1997 - 2002 Corvette: Service Bulletin: Door Rattle with Moderate to High Audio System Volume

Number: 01-08-64-009A

Subject: Door Rattle with Moderate to High Audio System Volume

Model Year: 1997-2002 Chevrolet Corvette

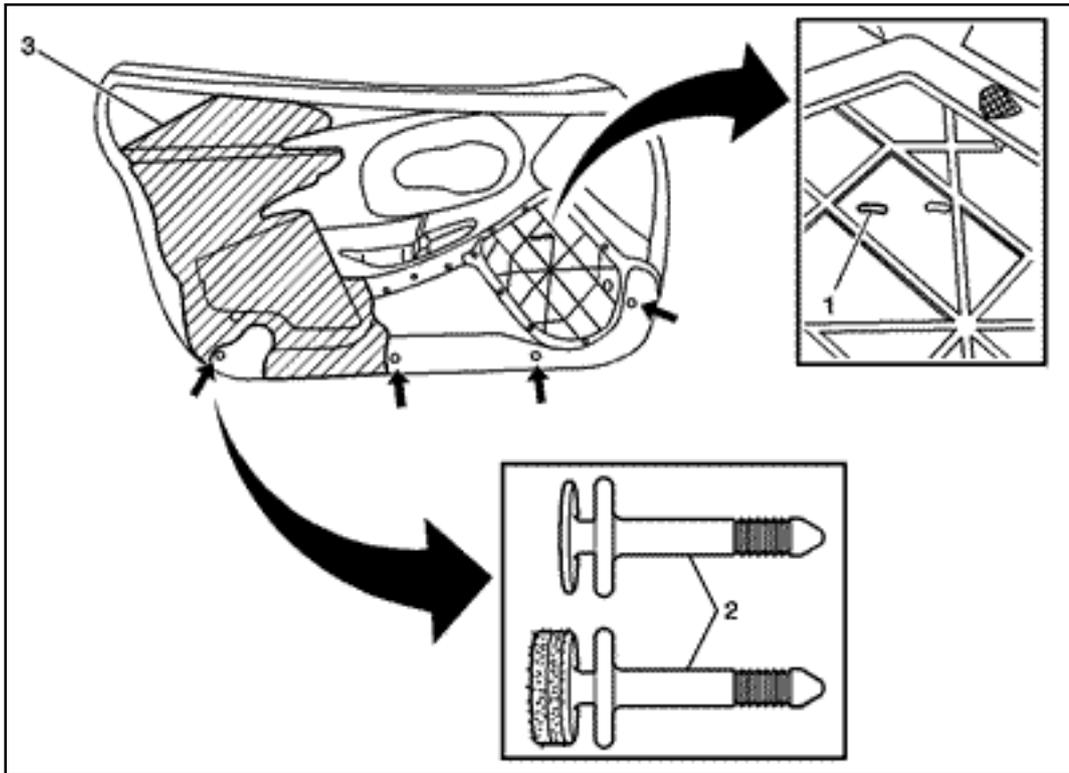
Change implemented in 2002 VIN breakpoint 125078. Vehicles built prior to this breakpoint will require the following procedure.

New speaker screen is made from a different material and Bose® emblem is provided due to risk of old emblem becoming damaged while removing.

1. Straighten the speaker grille tabs and remove the grille from the door panel.
2. Remove the Bose® emblem from the speaker grille and discard.
3. Remove the speaker screen from the grille and discard.
4. Install the new speaker screen to the grille.
5. Install the new Bose® emblem and carefully crimp the staples (1) to the speaker grille.
6. Insert the speaker grille tabs into the door panel slots and bend the tabs

to lock the grille in place.

7. Trim any extra loose door panel leather skin from around the speaker grille area on the back side of the door panel.
8. Repeat above steps for opposite side.

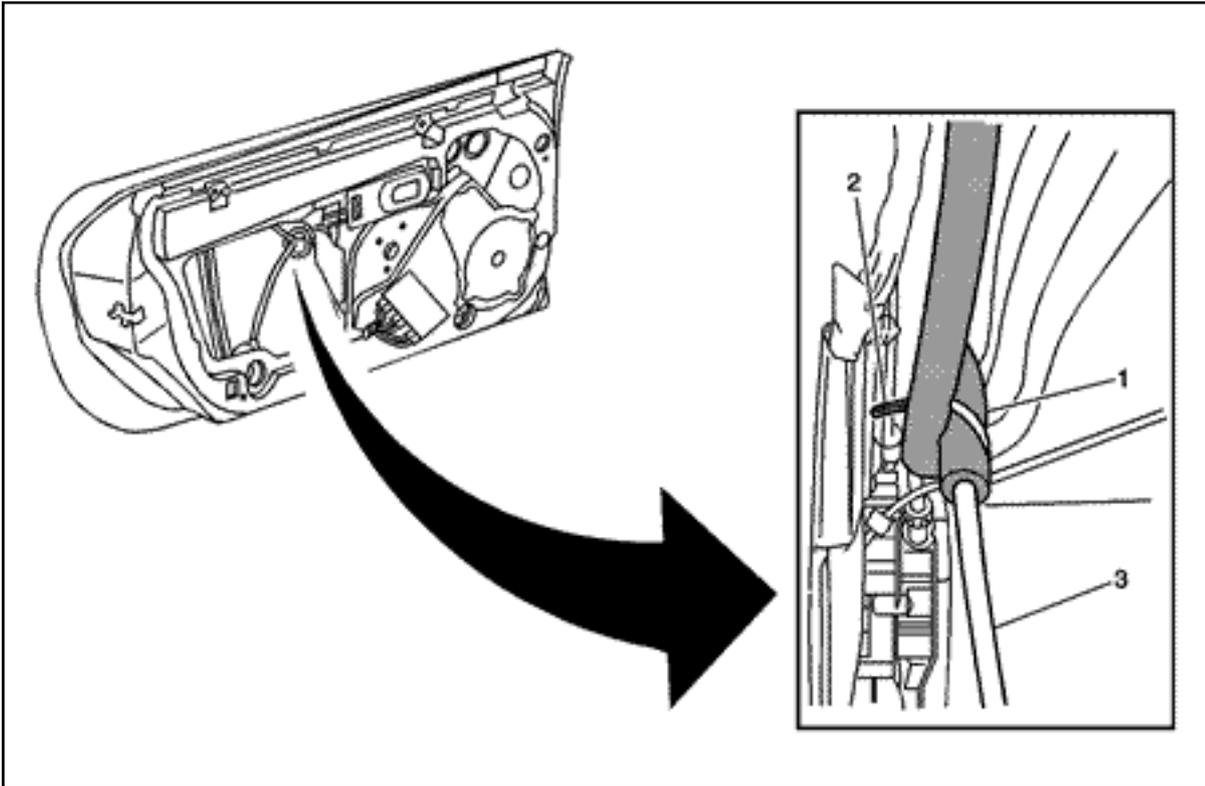
Change implemented in 2001 VIN breakpoint 115500. Vehicles built prior to this breakpoint will require the following procedure.

1. Remove the 4 lower door trim panel retainers (2) from both door panels.
2. Cut 16 dime sized coins from the fine side of Velcro®, 3M® P/N 051131-06481, or equivalent.
3. Install 2 Velcro® coins to each of the 8 door trim panel retainers (2).
4. Reinstall the door trim panel retainers (2) into the door trim panels.

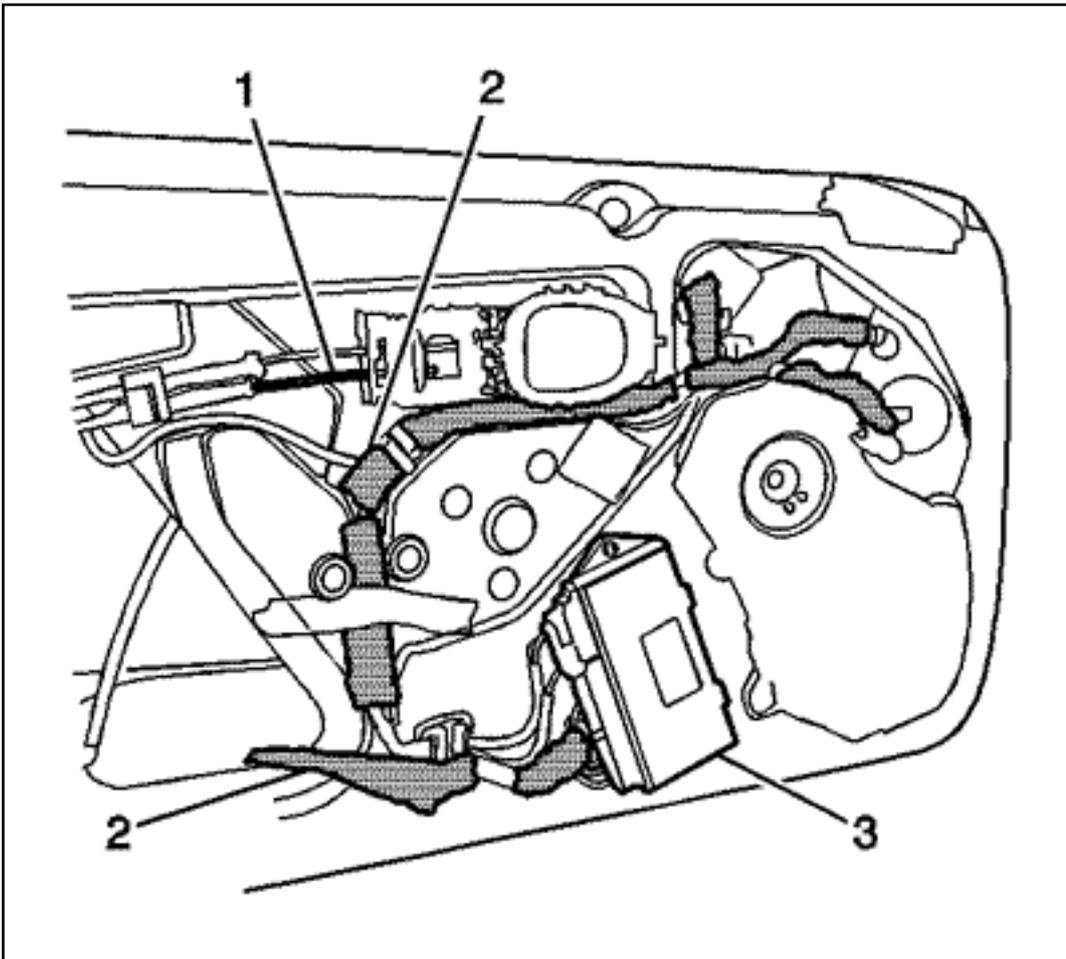
Change implemented in 1999 VIN breakpoint 133100. Vehicles built prior to this breakpoint will require the following procedure.

1. Remove the water deflector.

Do not damage the push-in retainer/tie straps (2). They are to be reused.

2. Remove the push-in retainer/tie straps (2) that retain the window regulator cables (3) to the inner door panels.
3. Reposition the push-in retainer/tie straps (2) out of the way.
4. Add 122 mm (5 in) of 3M® Open Cell Interior Foam Tape (1), P/N 051131-62385, or equivalent, to the window regulator cables (3) where they contact each other and the inner door panels.

5. Reinstall the push-in retainer/tie straps (2).
6. Reinstall the water deflector.

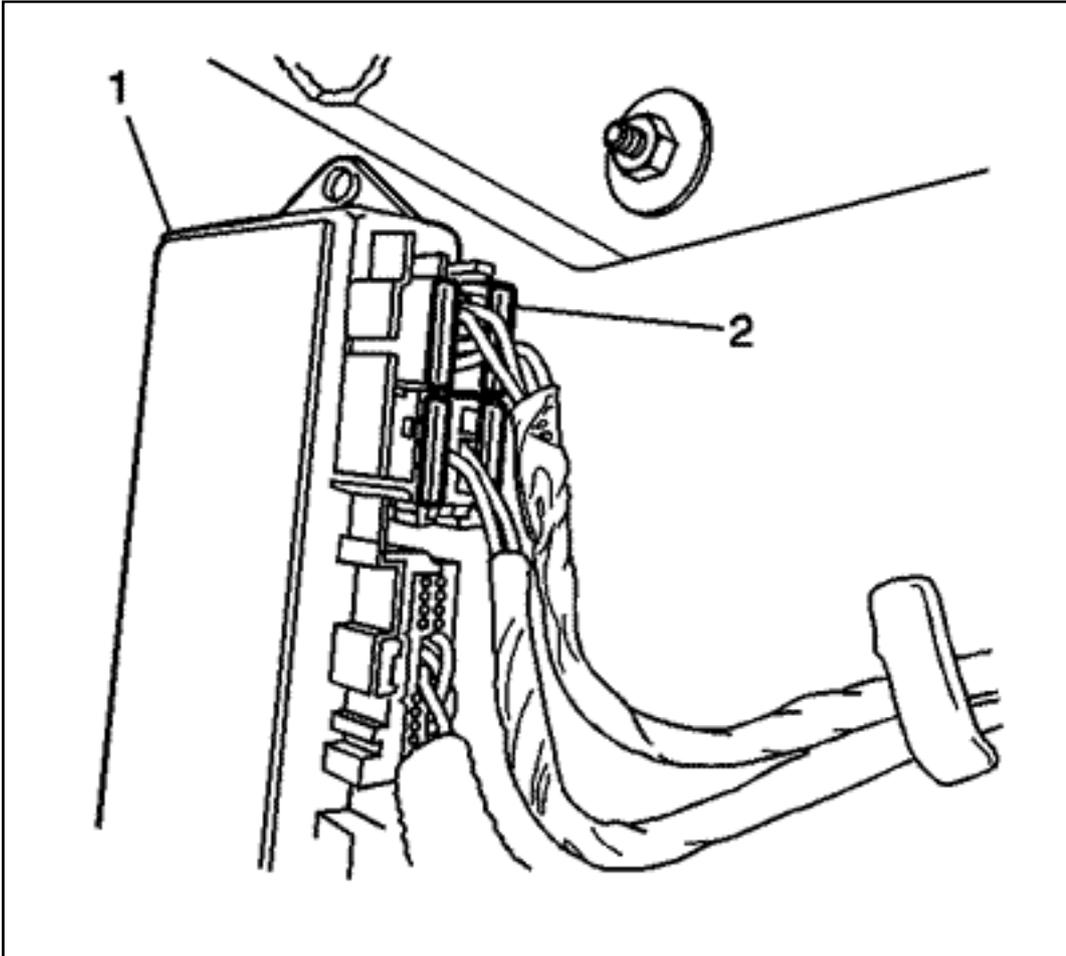
Change implemented in 2000 VIN breakpoint 101578. Vehicles built prior to this breakpoint will require the following procedure.

1. Remove the wire harness (2) from its retainers.
2. Insulate the wiring harness and in-line connectors (2) where the wiring harness and the in-line connectors (2) contact the door with 3M® Open Cell Interior Foam Tape (2), P/N 051131-62385, or equivalent. It is best to insulate the entire wiring harness (2).
3. Insulate the right door speaker connector with P/N 12378189.

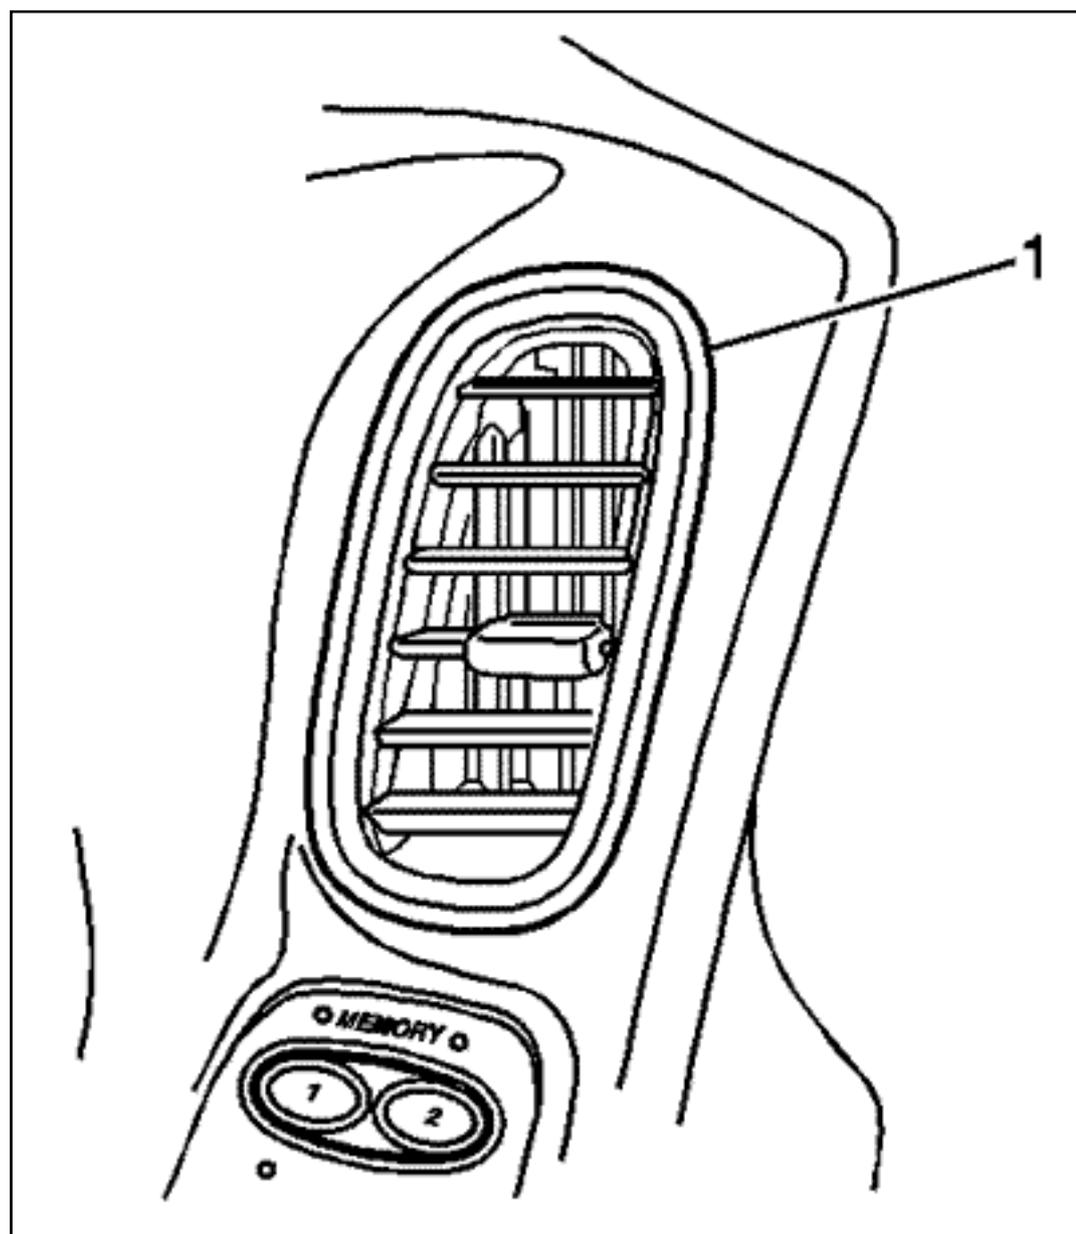
Change implemented in 2000 VIN breakpoint 120397. Vehicles built prior to this breakpoint will require the following procedure.

Add a small piece of duct tape, 3M® P/N 051131-06969, or equivalent, to the door control modules (1) terminal positive assurance (TPA)'s (2). They are grey in color and there are a total of 4 TPA's (2) per door. If the TPA's (2) are blue, they are the new design and do not need to be taped.
